**TOWN OF BAY HARBOR ISLANDS
PLANNING AND ZONING BOARD**

FINAL AGENDA

HARBOUR PARK APARTMENT BUILDING

Subject: Harbour Park Apartments
9901 E. Bay Harbor Drive
Proposed Revisions from Original PZ Board Approval
Bay Harbor Islands Acct. No. MB2012-39
MMPA Acct. No. 01-0702-0951

LEVEL 1 FLOOR PLAN (PARKING GARAGE) - REVISED FOR CONSTRUCTION
 SCALE : 3/32" = 1'-0"

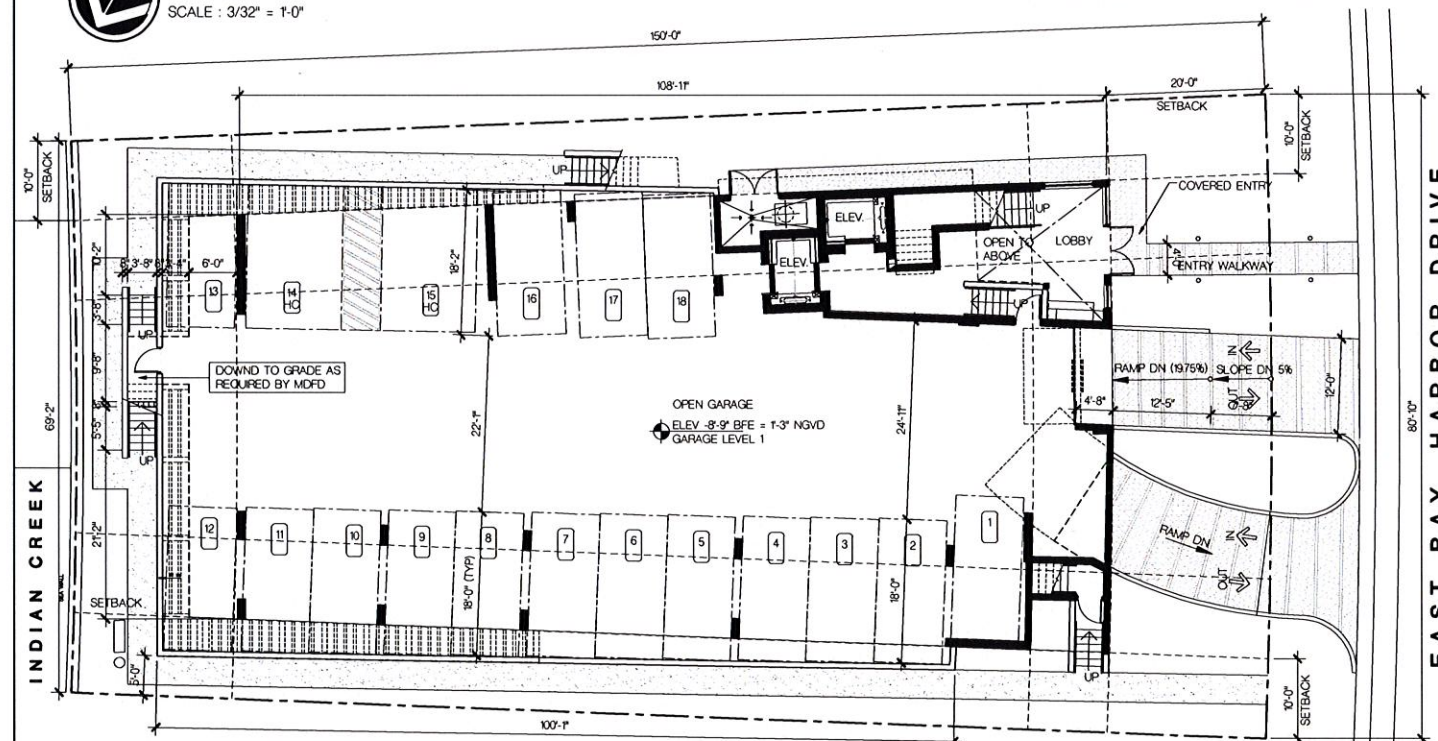
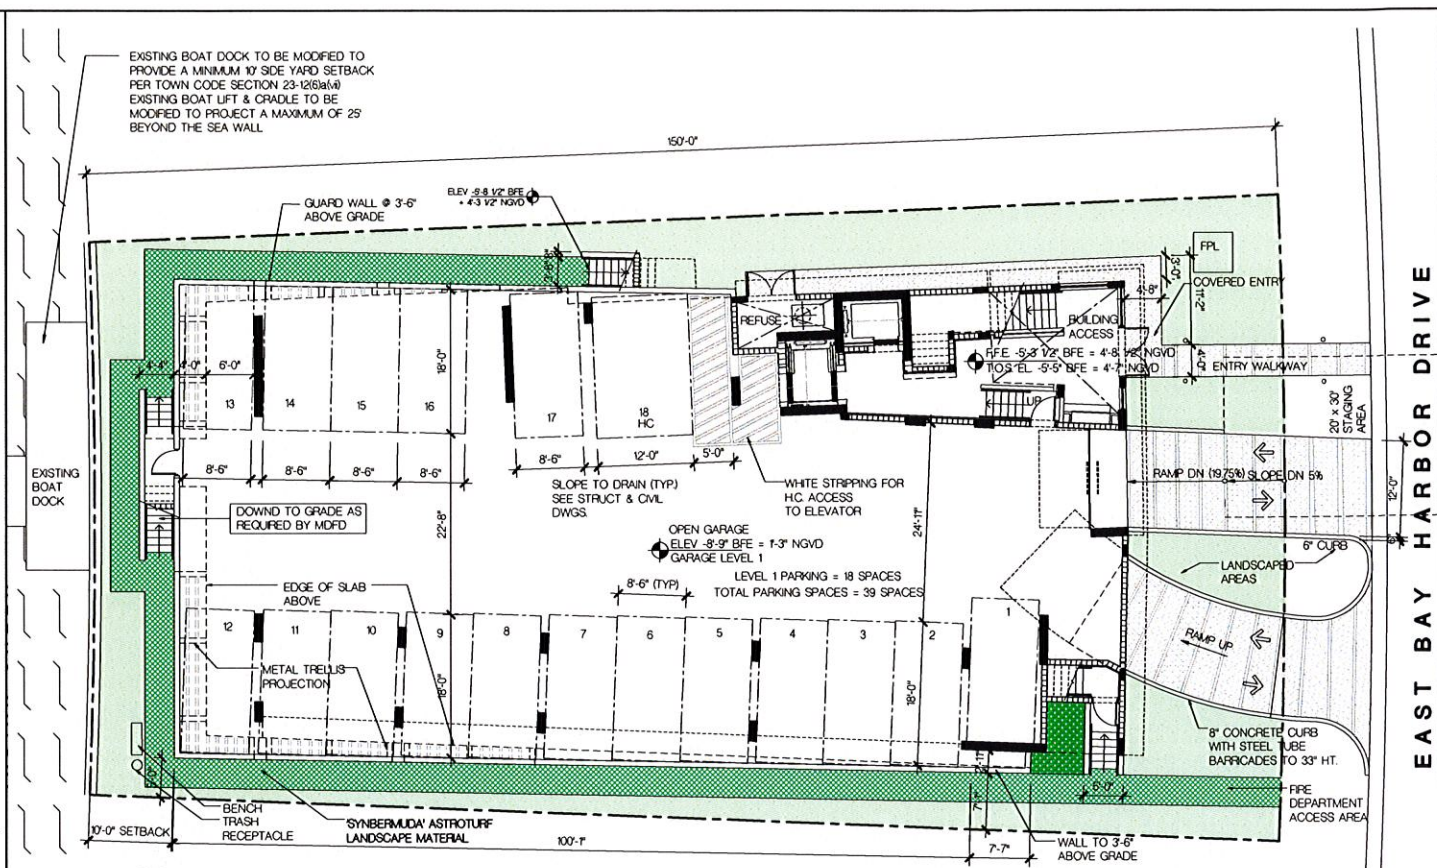
- 1) After the PZB approved the plans, the FD required additional exiting out of the parking garage and around the building. This is apparently a requirement that had never been imposed before that the Town has seen. Had the applicant / Town known about this previously the site plan would have been revised. As the Town issued Building Permits and the building is under construction it would be impossible to alter the building placement and parking facilities. In light of the above, the Town administratively approved the Astroturf product and placement in this instance. This applies to only this site – the lot is a pie lot with only 69' width at the rear PL (normally 75') and 80' at the front PL. As the lot converges near the rear PL site improvements are "squeezed" forcing an odd building configuration and parking layout. Any similar feature on other sites will have to meet minimum setbacks requirements. The downside is vertical landscaping (trees / shrubs) cannot be planted on the stabilized walkway areas, as was shown on the approved Landscape Plans. The land area beneath the Astroturf path cannot be counted as part of the minimum 20% open space requirement (the architect has confirmed the 20% can be met without counting this area. The applicant has revised the landscape plan. **PZB approval is being requested for the design change.**

LEVEL 2 FLOOR PLAN (PARKING GARAGE) - REVISED FOR CONSTRUCTION

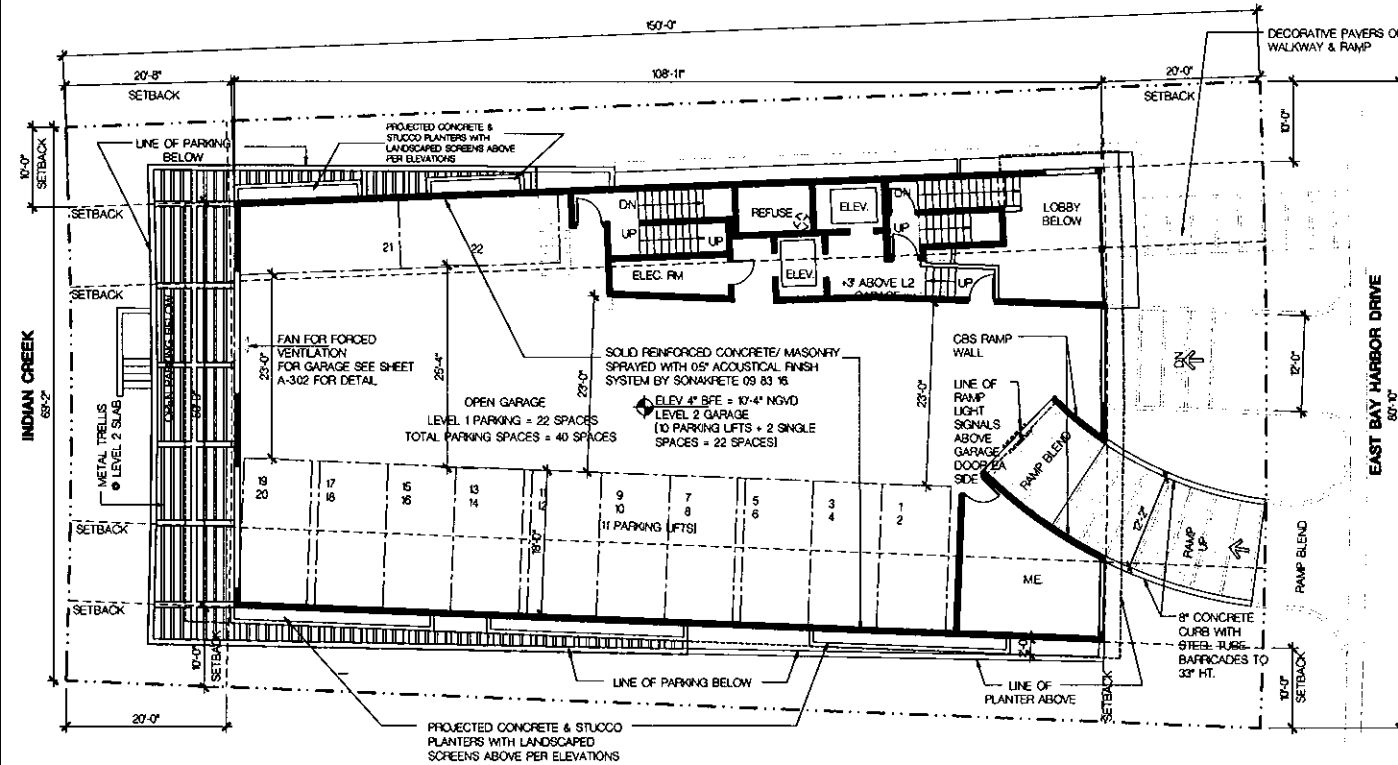
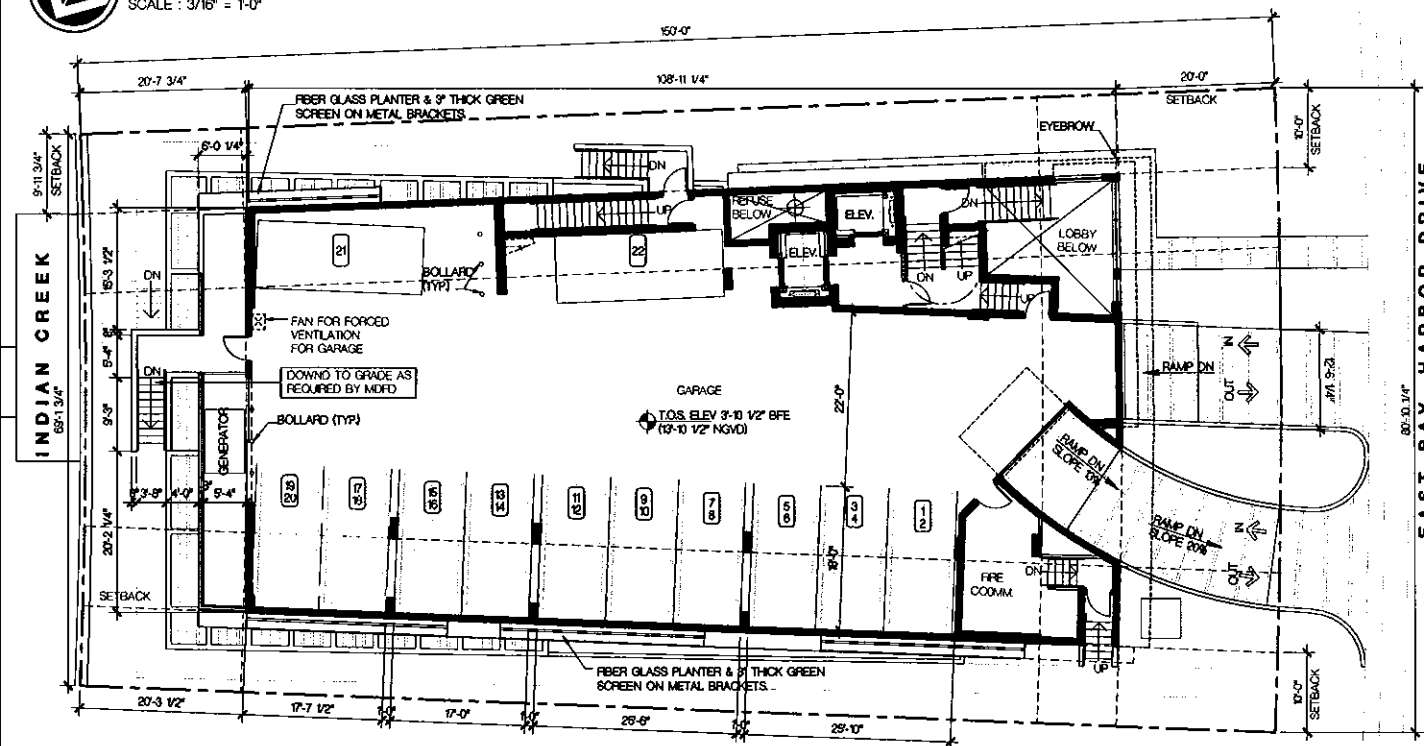
- 2) On Sheet A-1.02, a slab structure projecting six (6) feet toward the water from the 2nd Floor Parking Garage is shown and has been built. This feature was not shown on the approved PZB plans. The so-called "balcony", which is a common feature for a DU, was built for a proposed generator (not approved by PZB / now relocated internally) and now acts as a cover over part of the at-grade parking lot / pedestrian balcony / Fire Department exiting. The only access to this feature is from the Fire Department exit corridor and is adjacent to the rear of the 2nd level parking garage. The PZB approved a continuous metal trellis covering the entire parking area extending out from the rear of the building. Trellis structures are allowed in this yard area if approved by the PZB – and they did. The rear yard setback is 20 feet in this district. The trellis structure extends out further and covers the rest of the parking spaces. The Code is not specific that a balcony must be accessed only from a DU. Section 23-12(15)a.v. allows balconies to project into rear yard setbacks on waterfront lots up to 6 feet. The revised plan complies with that Code section. **PZB approval is being requested for the design change.**

PROPOSED NEIGHBOR VIEW ELEVATION
SCALE: 3/16" = 1'-0"

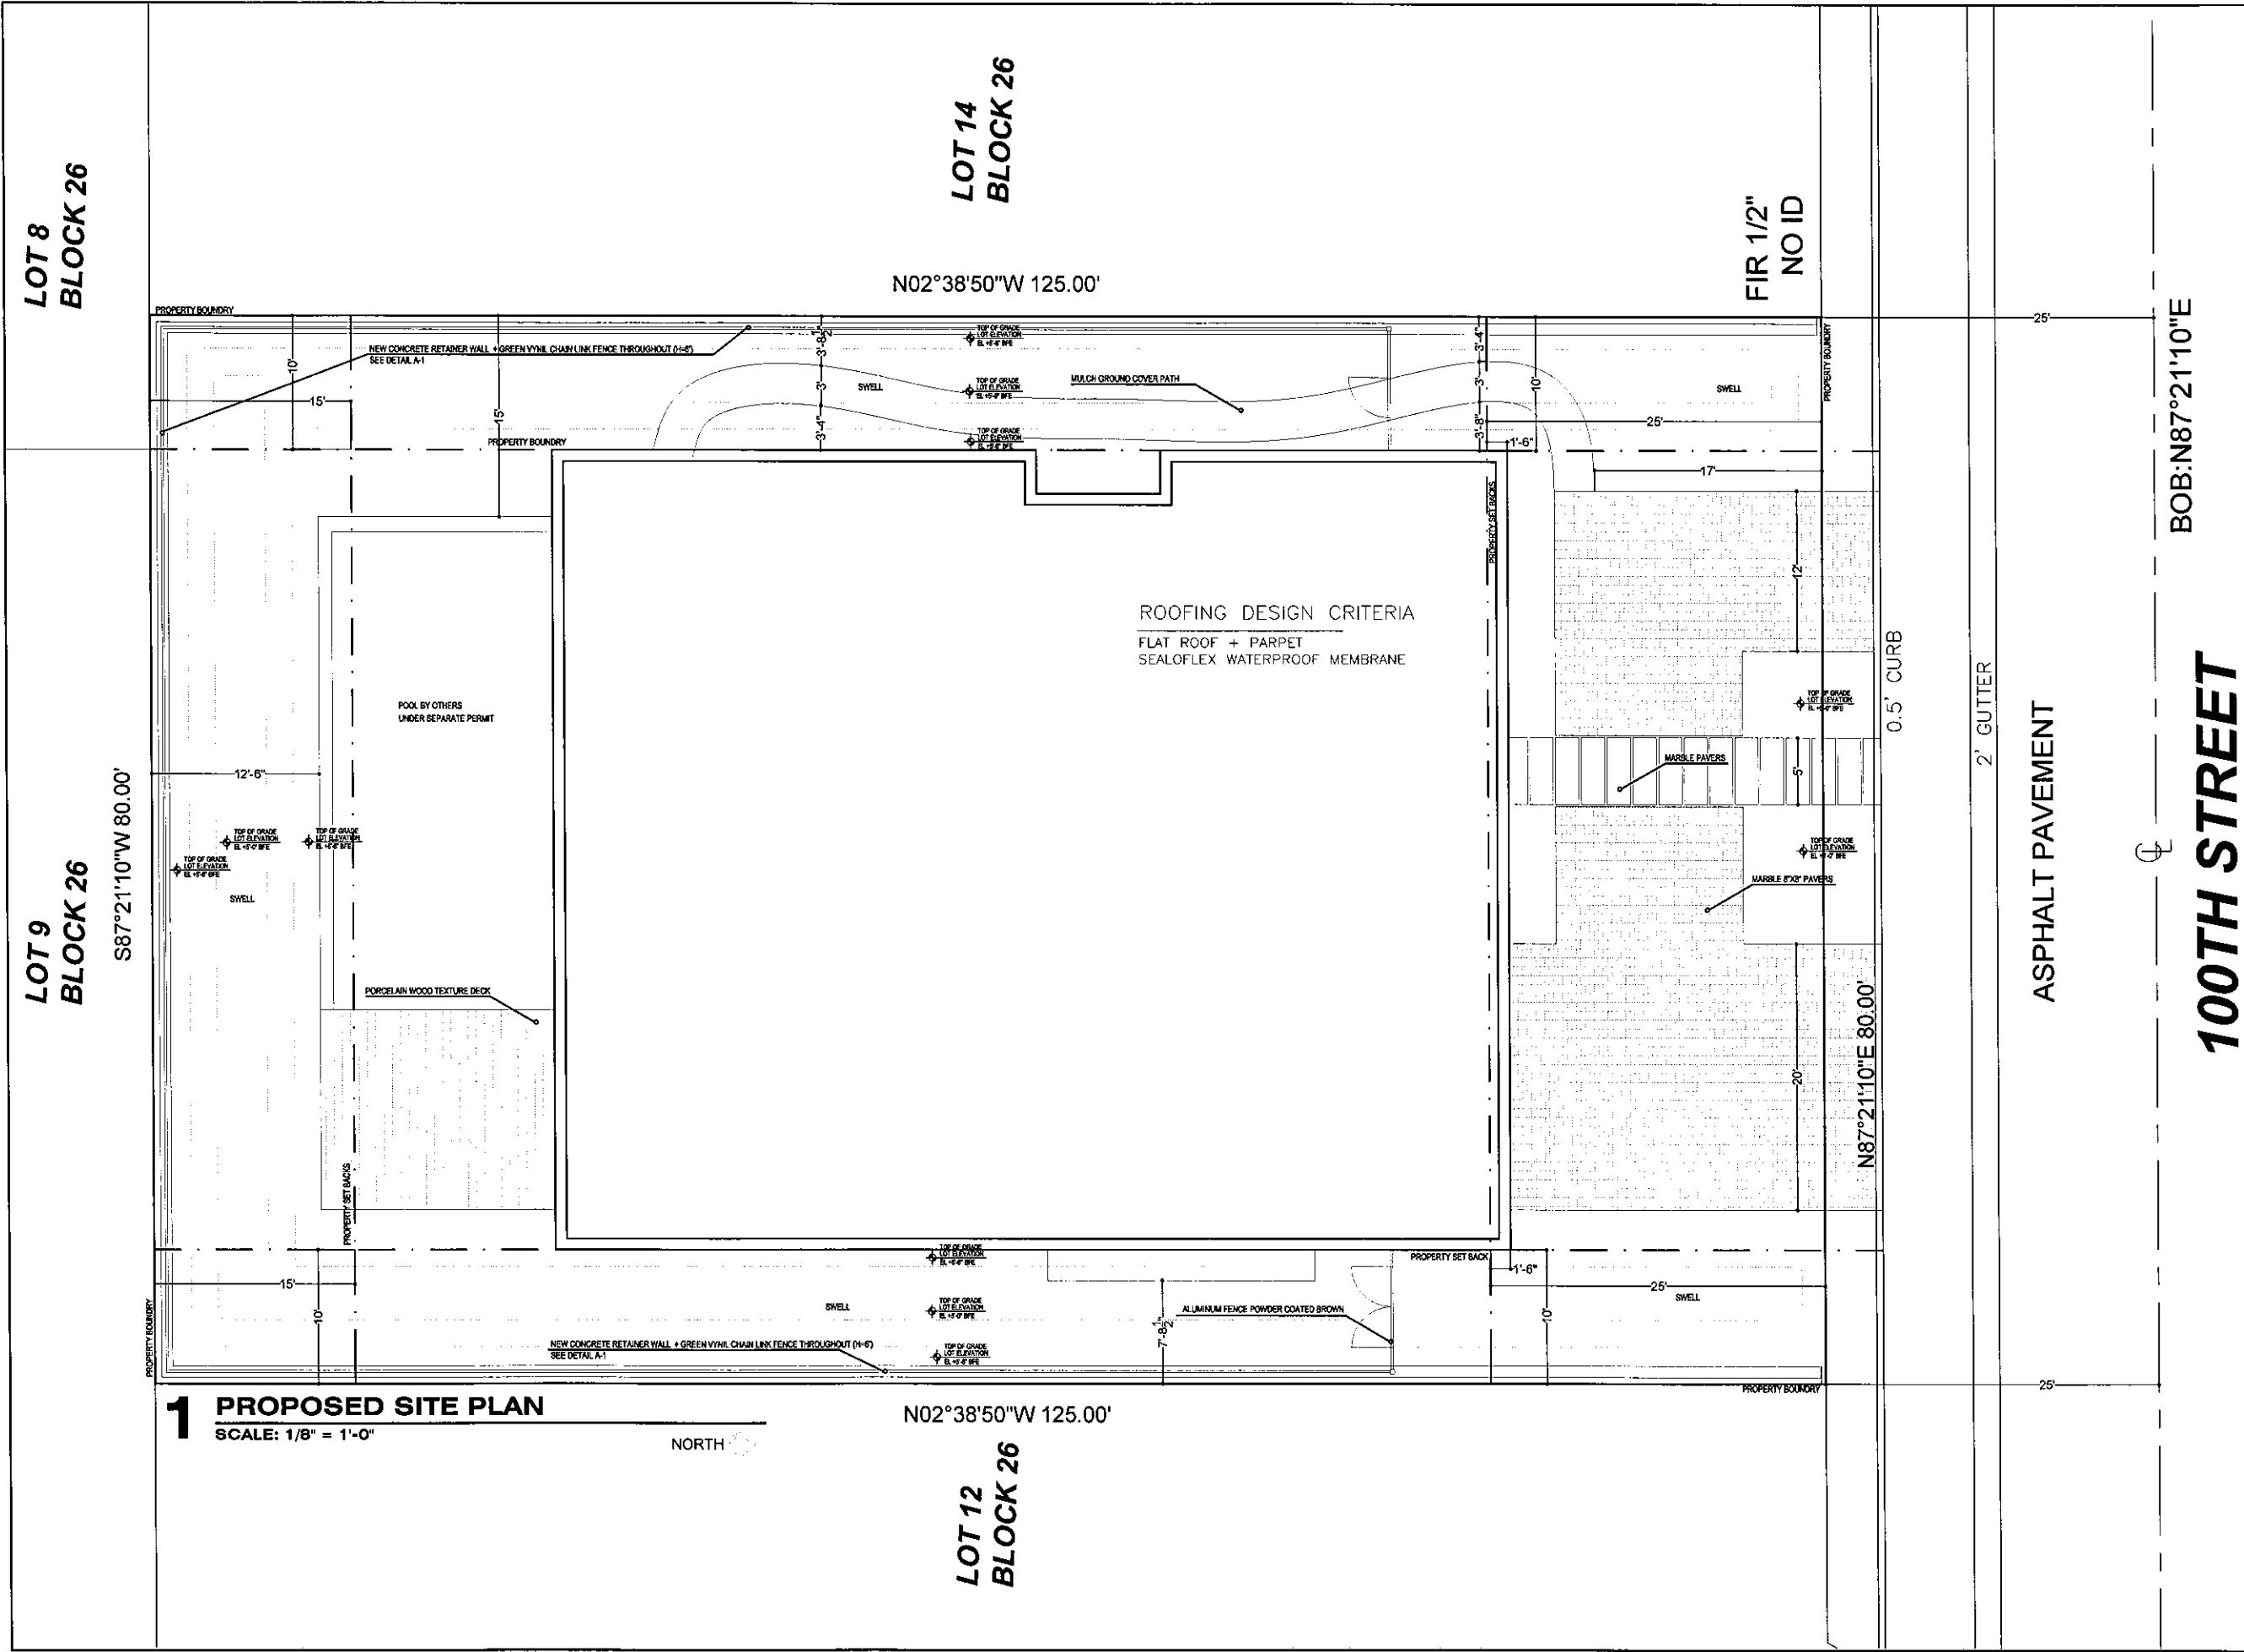
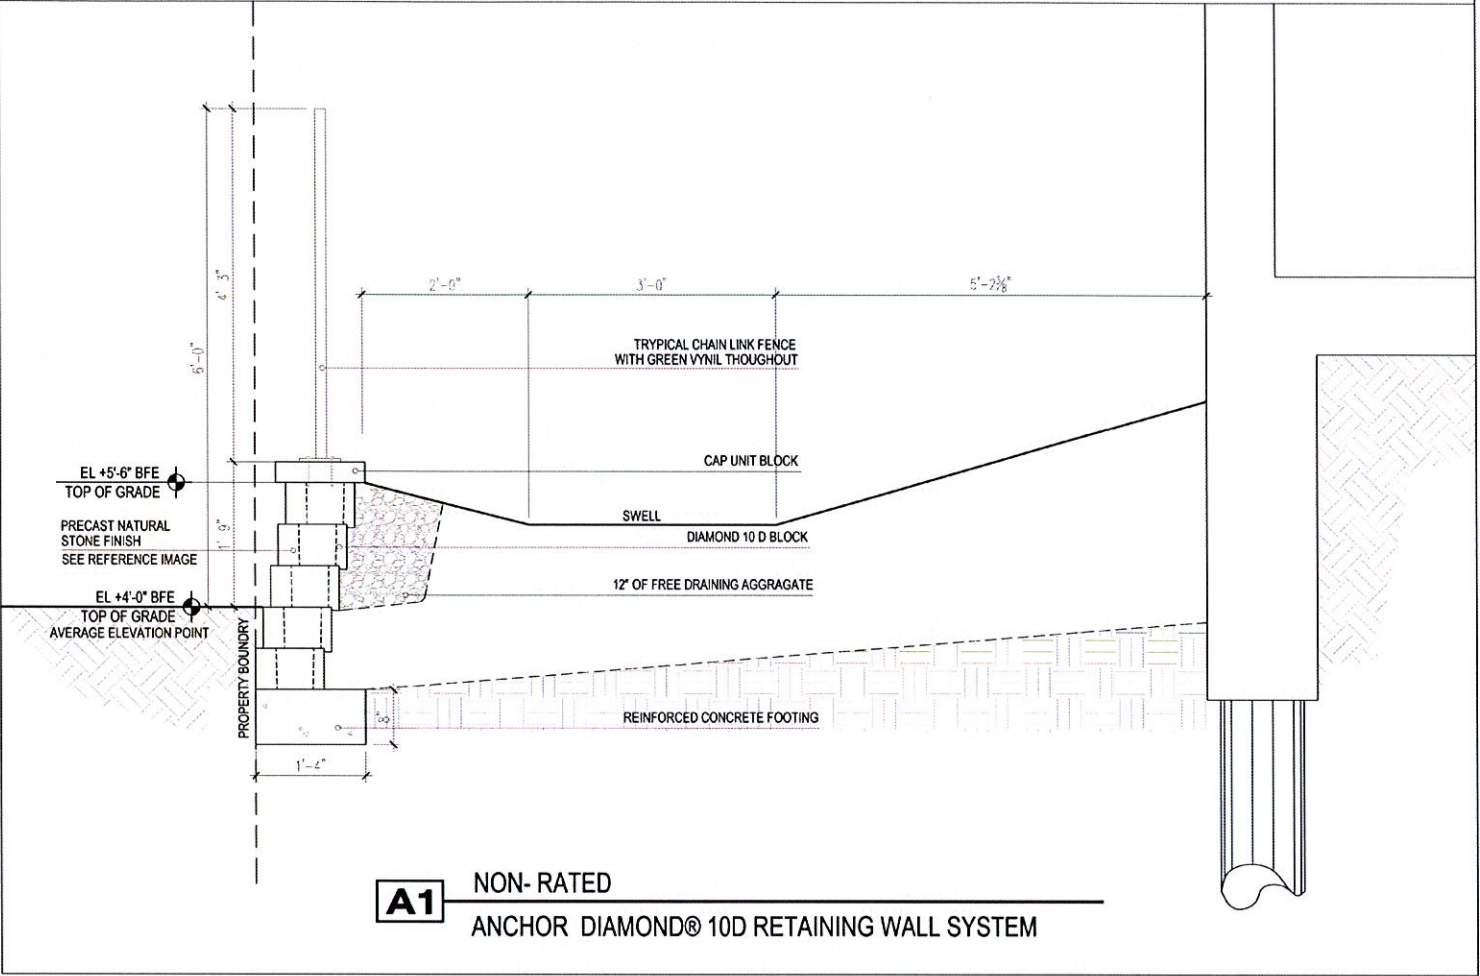
Raising the lot will make the finished grades at the adjoining lots unequal. Section 23-12(12) states that finished grades at adjoining lots shall be equal unless the PZ Board approves a retaining wall system. Therefore, Planning and Zoning Board approval is required for the retaining wall system proposed.
